**Thompson's Station Planning Commission
Staff Report - Item 2 (FP 2018-017)
May 28, 2019**

Final Plat Request for Rooster Creek for the creation of 3 lots.

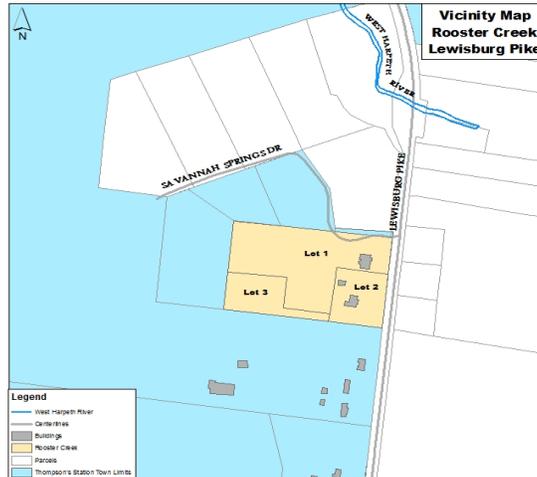
Rooster Creek consists of the re-subdivision of four lots into three single family lots adjacent to the Savannah Springs neighborhood. The setbacks for the D1 zoning district are 25 feet for the front yard, 20 feet aggregate with a minimum of five (5) feet for the side yard, and 30 feet for the rear yard. The lots are shown with building envelopes that comply with the minimum setback requirements.

The proposed plat is adjacent to a neighborhood located within Williamson County – Savannah Springs. Savannah Springs takes access from Lewisburg by a private easement partially located on Lot 1 of the Rooster Creek plat. The easement contains a 20-foot-wide paved private driveway which provides direct access to each lot within Savannah Springs and to the proposed Lot 3 of the Rooster Creek plat.

The Town’s LDO states if a permanent easement is utilized for access to a lot, it must be 50 feet in width. The LDO further states that if the easement “is proposed to provide access to more than five lot or tracts of land, an access way shall be constructed within the easement which will meet or exceed the standards for design and construction of public ways. . .” (Section 3.7.2). The typical cross section for a 50-foot local roadway consists of a five-foot sidewalk and a five-foot landscape strip with the remaining width paved roadway and curb and gutter. The existing access easement is 50 feet; however, Savannah Springs Drive has a paved width of 20 feet. The applicant is proposing another 50-foot access easement which will provide access to Lot 3 through lot 1 connecting to Savannah Springs Drive. This access easement has an existing gravel driveway recently installed. The applicant is requesting a deviation from the requirement to the roadway requirement because “Savannah Springs Drive has existed with the stated horizontal width for approximately twenty years and either equals or exceeds the travel lane width(s) of the transect zoning travel lane widths for the design speed in Table 3.7 of the Sub Regs” (refer to attached letter dated May 8, 2019).

Upon consideration of the request, Staff noted the road is a private driveway that is owned and maintained by an HOA in an area without curb, gutter and sidewalks. Requiring the inclusion of curbs, gutter and sidewalks would be inconsistent with the surrounding community at this time. A 20-foot-wide paved roadway provides enough width for two 10-foot travel lanes which has been the access for the residents since the development of the neighborhood. It may be a practical difficulty to require the applicant to install a standard roadway section for the portion of the property located within the Town while the majority of the private driveway is located within Williamson County. In addition, the responsibility for maintenance resides with the HOA for Savannah Springs, therefore, this road will not become the responsibility of the Town. Therefore, Staff supports the deviation from the public road standards for the private access easement

At this time, there is a dispute between the developer and the Savannah Springs HOA/property owners as to the developer's right to use the property for this subdivision. Since this involves a private easement/road, Staff cannot confirm that the developer has a legal right to use the easement and therefore recommends a deferral to June in order to provide time for the applicant to secure access.

Based upon the lack of agreement regarding the use of Savannah Springs Drive, Staff recommends that the Planning Commission defer the request to the June Planning Commission meeting to give the applicant time to secure approval for the use of the private easement.
